From: Stoltz, Carrie R - DNR
Sent: Tuesday, October 17, 2017 9:00 AM
To: 'Jason Powell, METCO - Staff Scientist (jasonp@metcohq.com)'
Subject: Port Wing Report review
Attachments: 20171017074419878.pdf

PORT WING AUTOMOTIVE

PORT WING, WISCONSIN

SOIL CONTAMINATION

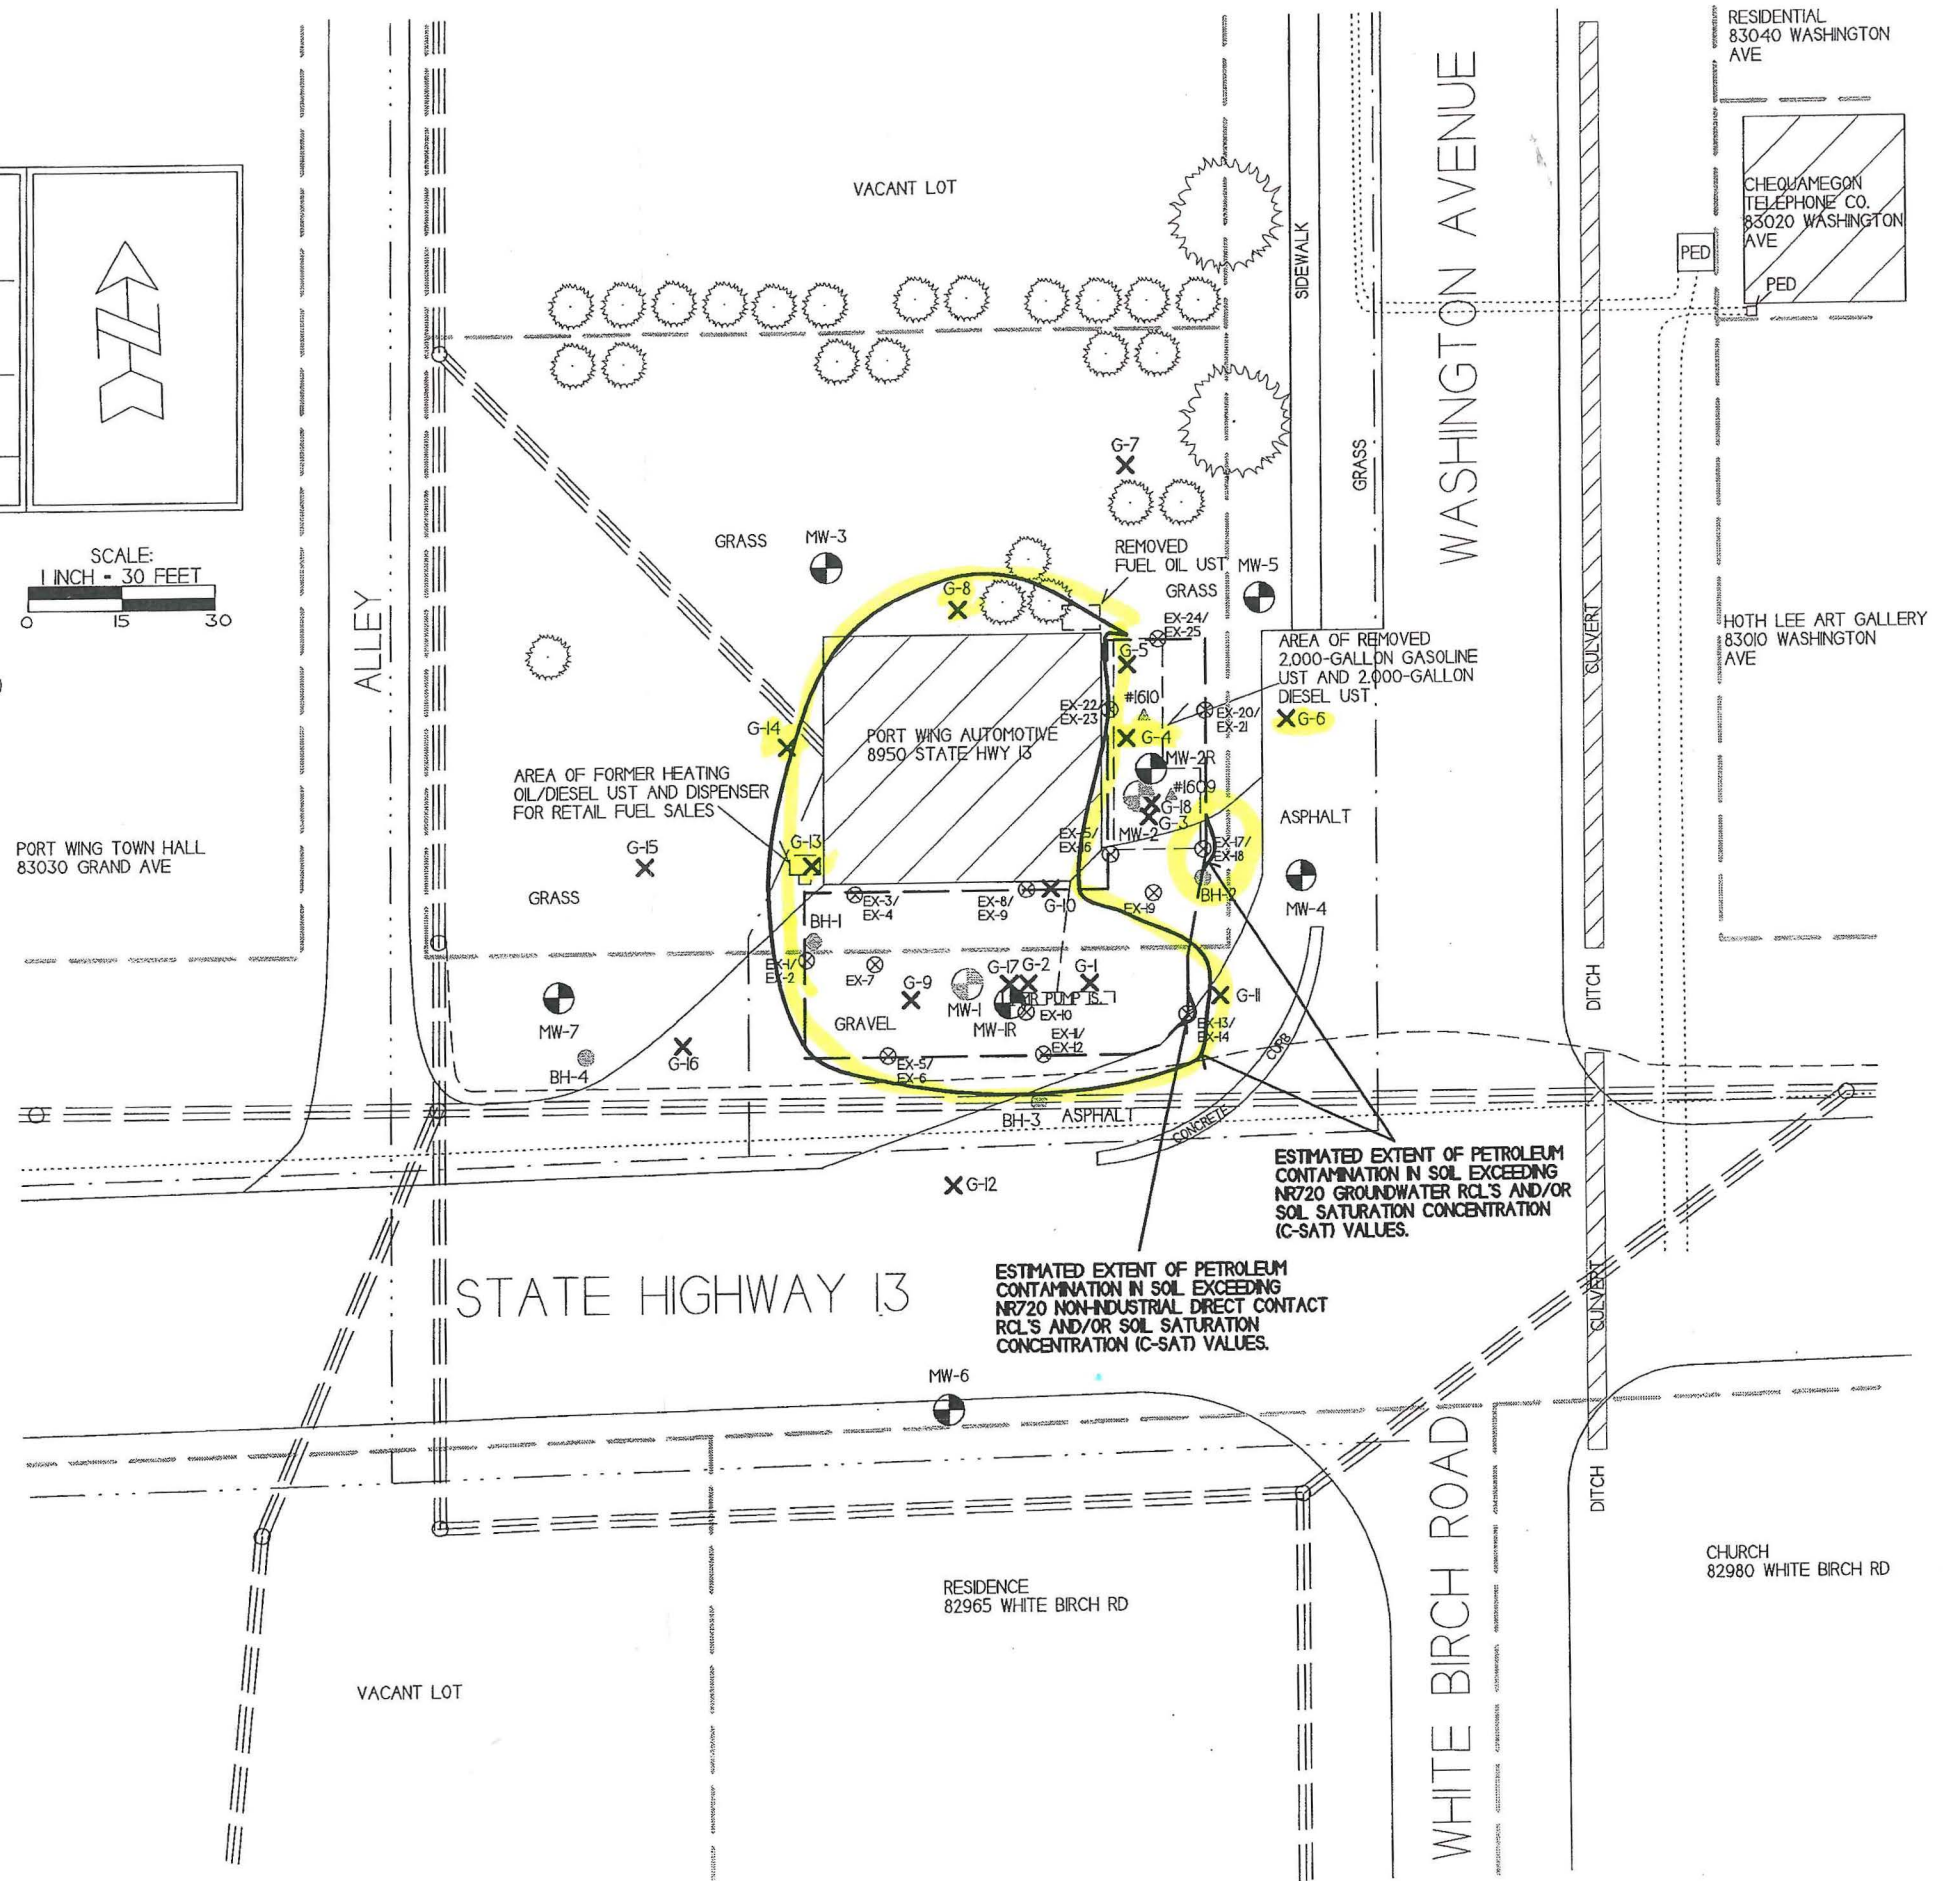
Hi Jason, I just finished reviewing the Port Wing letter report. Just a couple of comments. Attached is the extent of soil contamination, excavation area and groundwater flow figures. The extent of soil contamination should reflect lab results. It does not appear as though the soil contamination extends as far as it is presented. Some of the lines should be dotted instead of solid. I would recommend updating this figure. Also, the contours of the GW flow map look strange (not enough points to accurately depict contours), but this can wait until we have more data. If you have any questions, let me know. Thanks, Carrie

EXCAVATION AREA	
PORT WING AUTOMOTIVE	
 709 Gillette Street, Suite 3 La Crosse, WI 54603 Tel: (608) 781-8879 Fax: (608) 781-8893 <small>Excellence through experience™</small>	PORT WING, WISCONSIN DRAWN BY: ED DATE: 12/13/2013

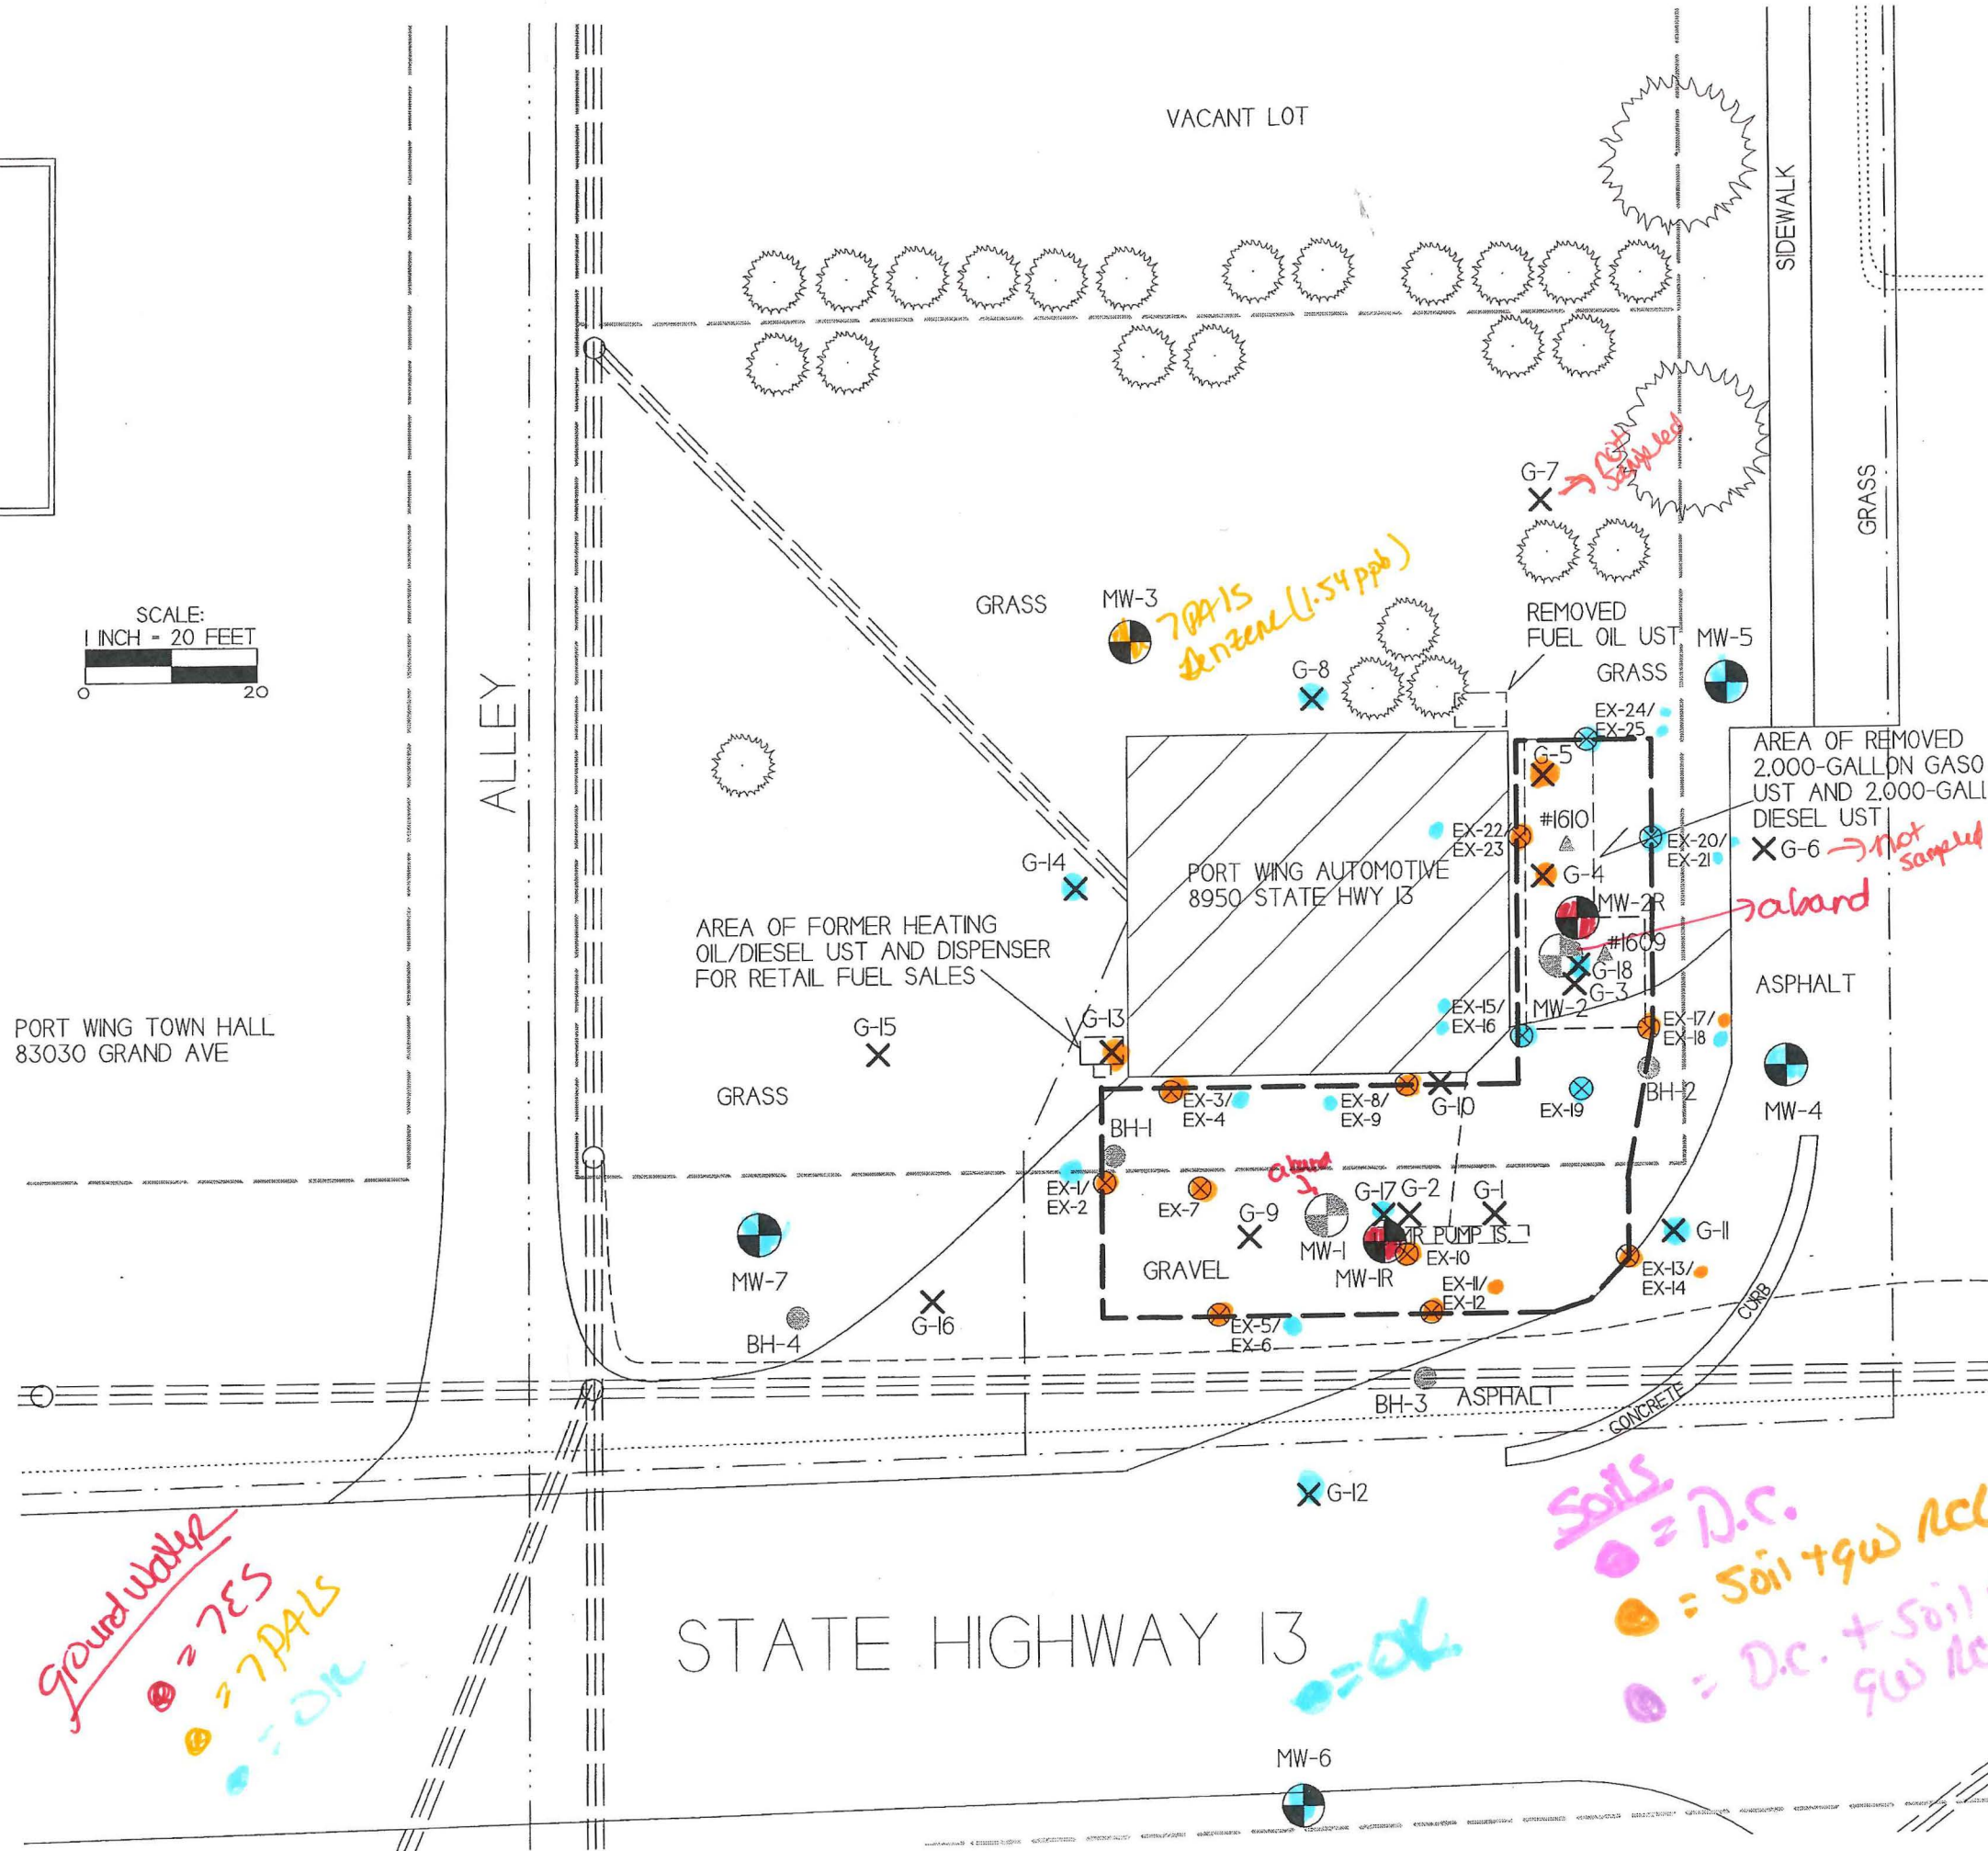
Ground water
 ● = 7ES
 ● = 7PALS
 ● = DR

Soils = D.C.
 ● = Soil + gw AcIs
 ● = D.C. + Soil to gw AcIs
